COUNCIL ACTION FORM

**SUBJECT: ENCROACHMENT PERMIT FOR 2408 CHAMBERLAIN STREET
(CLOCKTOWER PLACE)**

ENCROACHMENT PERMIT
 2408 CHAMBERLAIN

PARTIAL PLAN

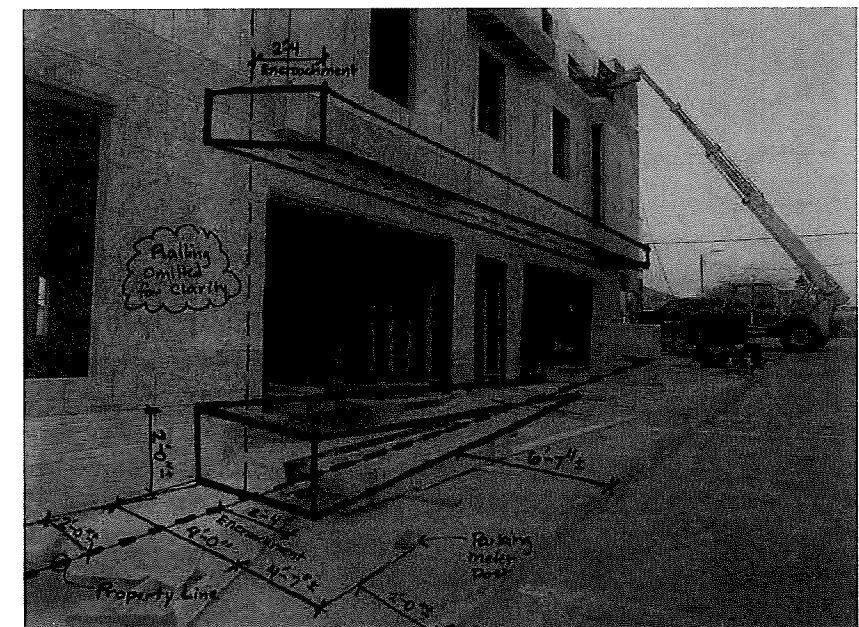
The developer received a façade grant (April 2017) and site plan approval (June 2017) for 2408 Chamberlain Avenue. **In both approvals, this encroachment was not identified on the plans.** There are two doors in the approved plan, a residential entrance and one retail door located to the west of the residential entrance. **The developer made decisions in the field for changes that add an additional door to the east of the residential entrance. The developer also had to address Building Code and accessibility requirements that were not addressed in the original Minor Site Development Plan approval. This is a significant issue due to the slope of Chamberlain Street and the proposed Finished Floor Elevations, the entrances are not level with the sidewalk. The developer has proposed constructing a platform, approximately twenty feet long that would serve all three entrances.** (Attachment A applicant information for Encroachment)

To have an accessible entry for the proposed location to the east, a pedestrian platform or ramp of some kind would be needed. The applicant proposes that rather than accommodate the access internal to the property and modify the building design, the platform straddle the property line and encroach into the abutting sidewalk area. The encroachment would be approximately 18 inches and narrows the sidewalk to approximately six feet seven inches (6' 7") along the platform area and down to four feet seven inches (4' 7") at the location where the parking meter is located.

SKETCH

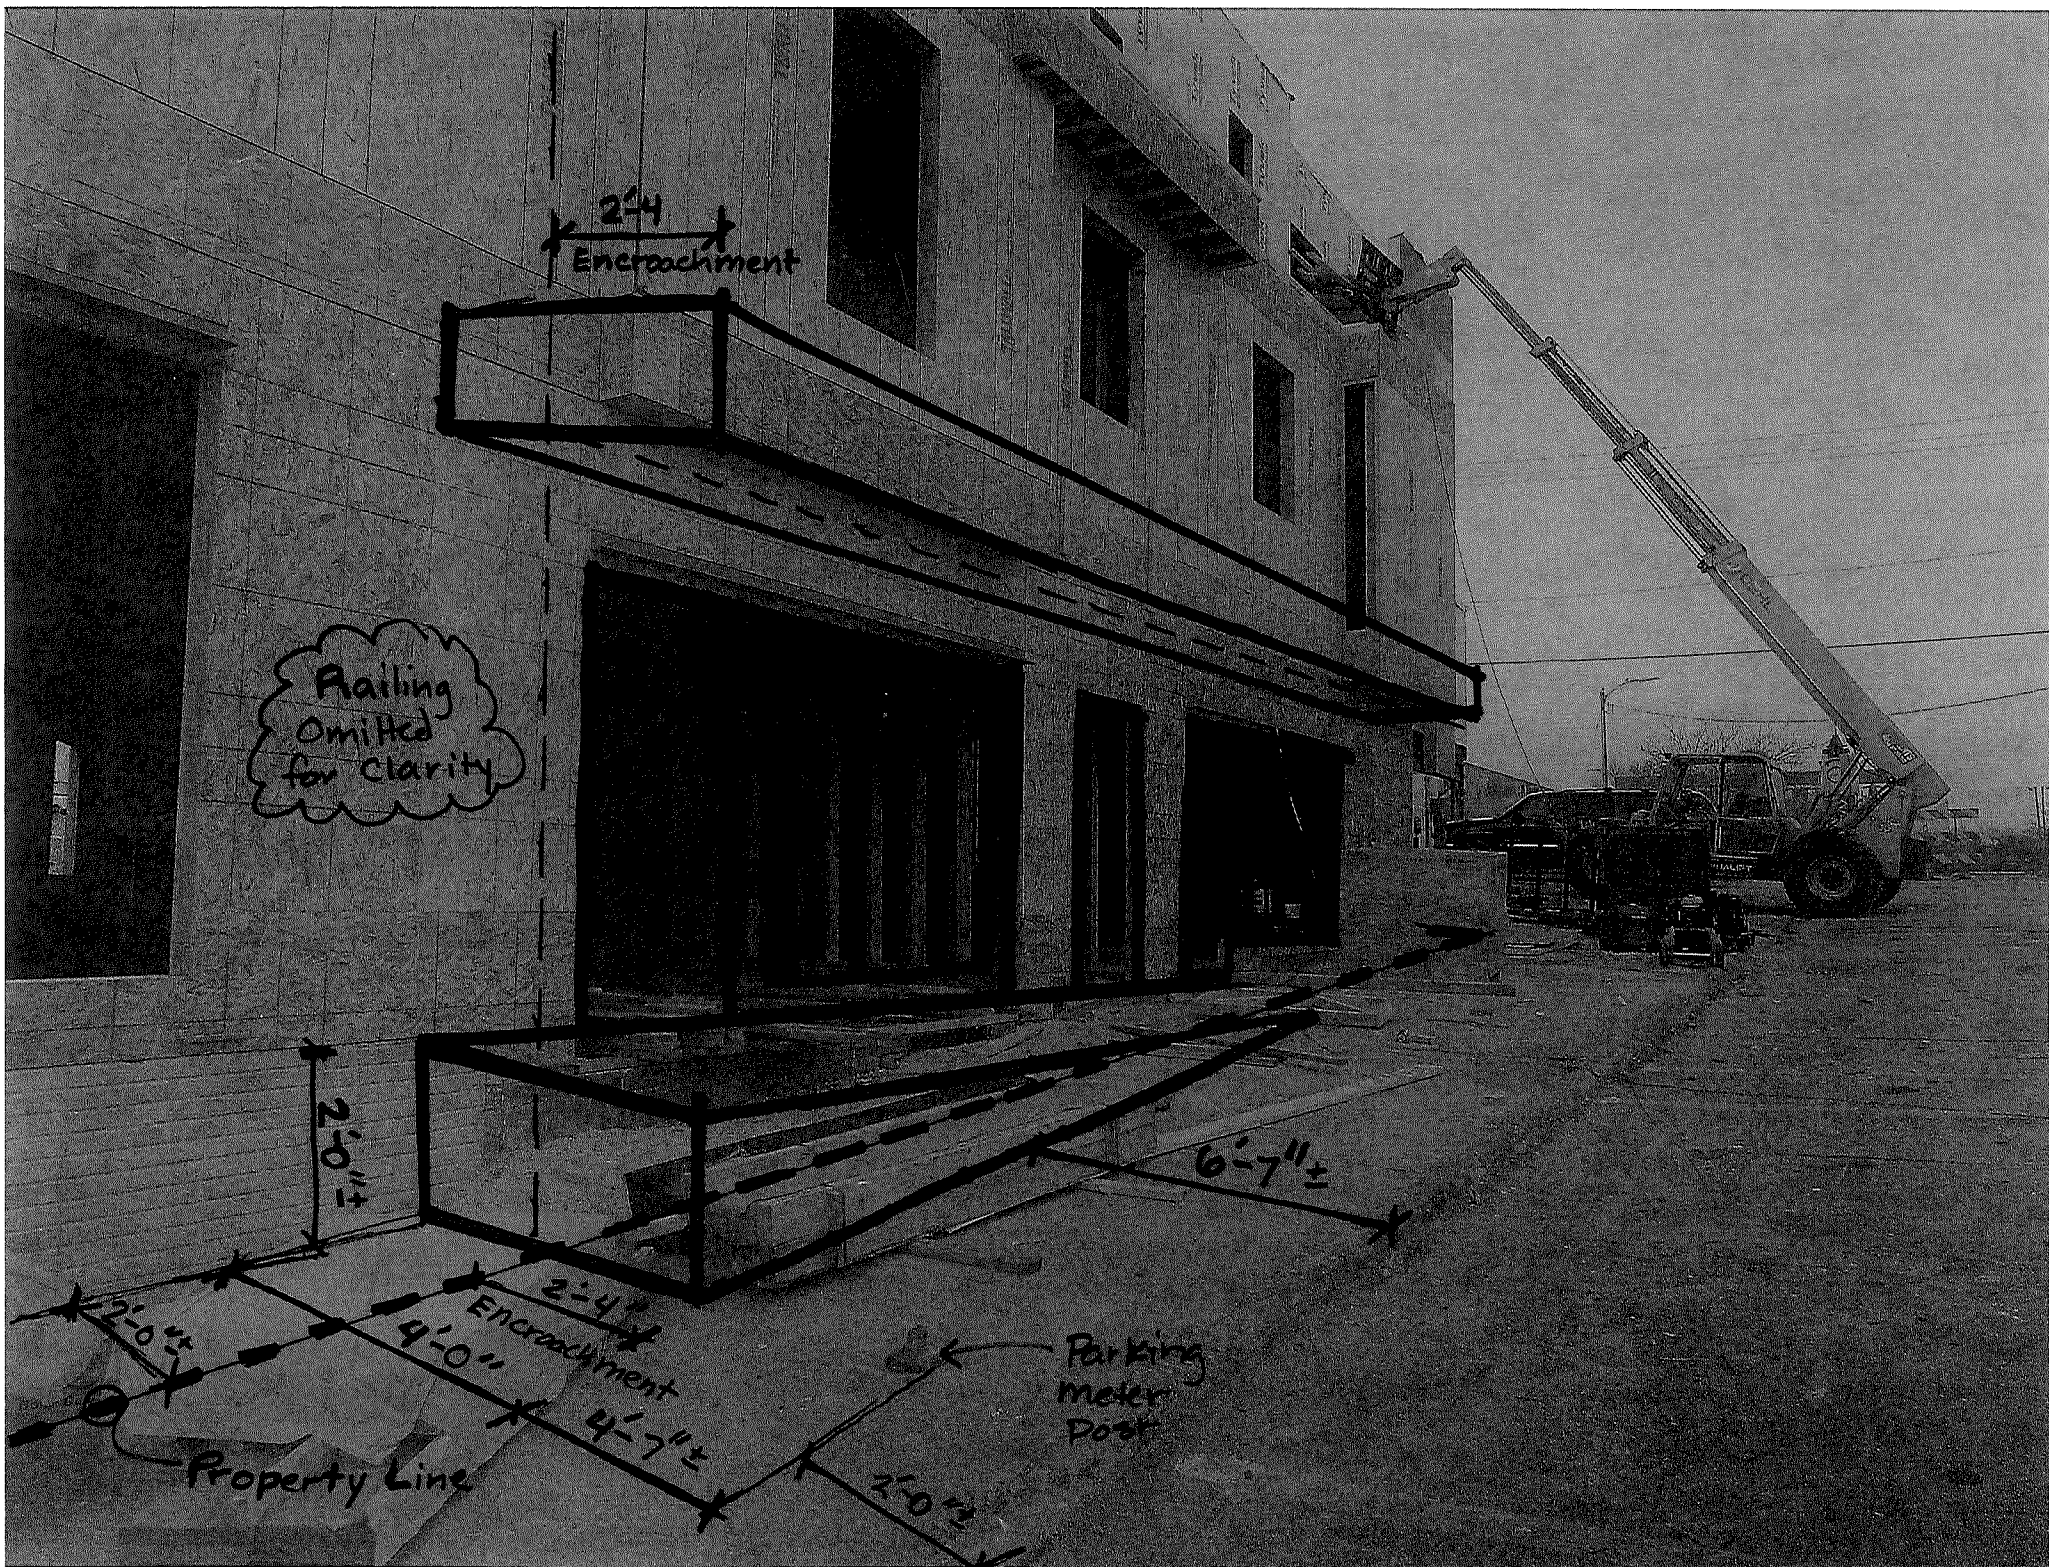
The City's public improvement standards rely upon conformance to SUDAS and standards within the *Municipal Code*. ***Municipal Code Section 23.403(14)(d) requires in commercial areas that walkways shall not be less than eight feet wide.*** Due to

this walkway width requirement, staff does not support the permanent encroachment that narrows the sidewalk width in this heavily traffic pedestrian area of Campustown. Council could consider a shorter length of encroachment, but the reduced sidewalk width would occur under any scenario. **If no encroachment is granted the applicant would have to reassess how they can comply with Building Code and accessibility standards within their own property lines. If an encroachment is approved staff does recommend that steps are included in the design at the east end of the platform in order to allow pedestrians an unobstructed path on the sidewalk. If approved, the proper amount of barricading must be erected to protect against pedestrians follow on the encroachment.**

Therefore, it is the recommendation of the City Manager that the City Council adopt Alternative No. 1, and thereby deny the encroachment permit for 2408 Chamberlain Street as described above.
